COMMERCIAL ENGINE BULLETIN

Detroit Diesel Allison

November 30, 1980

ENGINE, TURBINE EXHAUST COLLECTOR INNER CONE--MODIFY

FIGURE 1

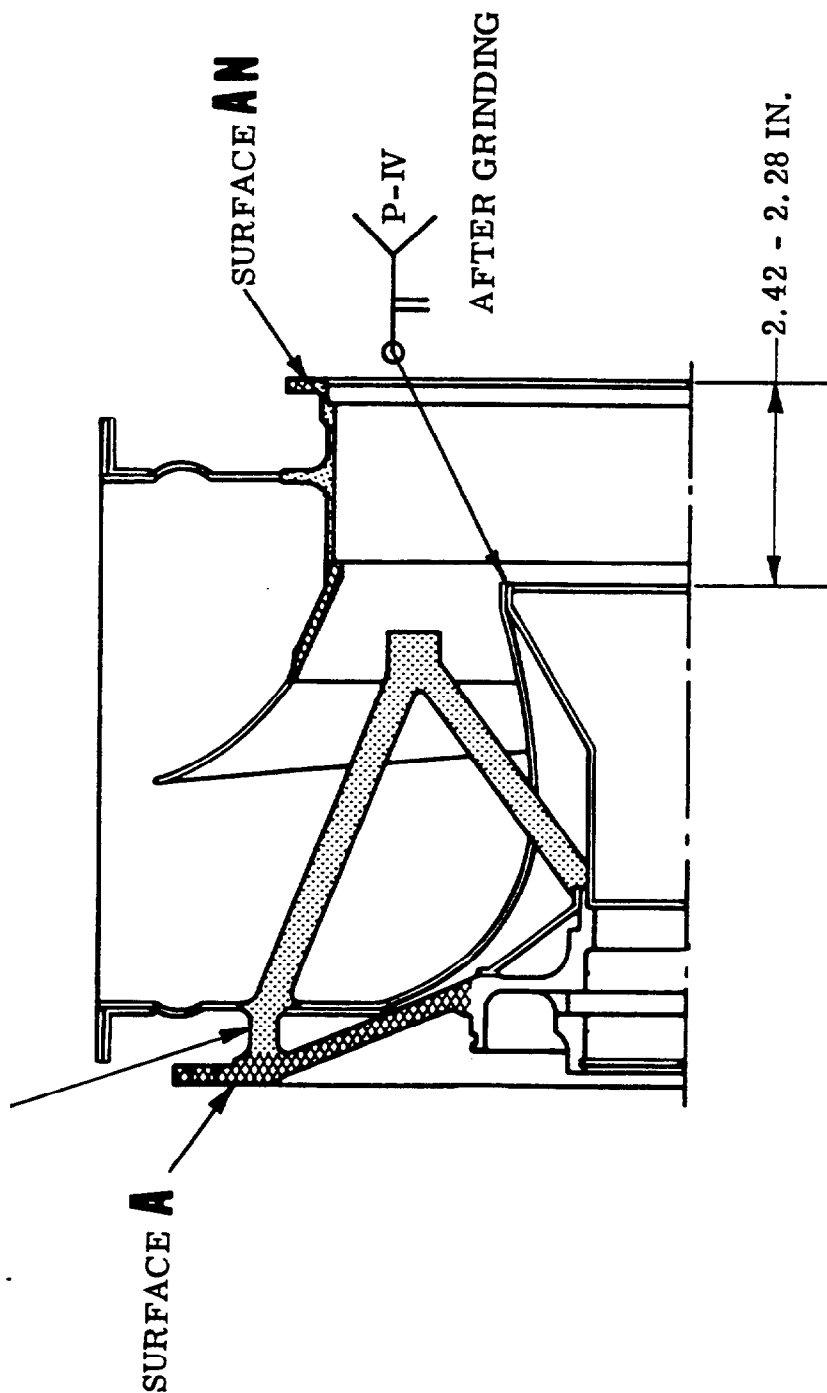
REASON: It is possible for the fourth stage wheel to contact the upstream edge of the -7 detail sheet metal inner cone of the exhaust collector under adverse tolerance stack conditions.

DESCRIPTION: The upstream edge of the -7 detail sheet metal inner cone of the exhaust collector is machined to obtain an increased minimum locating dimension from the power turbine support mounting flange.

- 1.0 Modify and reidentify affected P/N 6893075, 23001996, 23004240 or 23004509 Support Assemblies, Turbine and Exhaust Collectors.
Refer to Figure 1.
- 1.1 Ensure that support assembly, turbine and exhaust collector to be modified has passed the inspection criteria in the Overhaul Manual and is in fit condition for further service and to be modified.
- 1.2 Machine or hand grind the upstream edge of the -7 detail sheet metal inner cone to obtain the increased minimum locating dimension as shown in Figure 1. Reweld using inert gas arc, without filler rod.
- 1.3 Reidentify modified Support Assemblies, Turbine and Exhaust Collector by adding the suffix "CEB 72-3044" to the part number and any existing suffixes per AS478-2D1.
- 2.0 Record compliance with 250-C30 CEB 72-3044 in the Engine Log Book, Turbine Assembly (pink pages), Modification Record, Part III.

REIDENTIFY MODIFIED EXHAUST COLLECTOR
BY ADDING "CEB 72-3044" SUFFIX TO PART
NUMBER AND ANY EXISTING SUFFIX PER
AS478-2D1
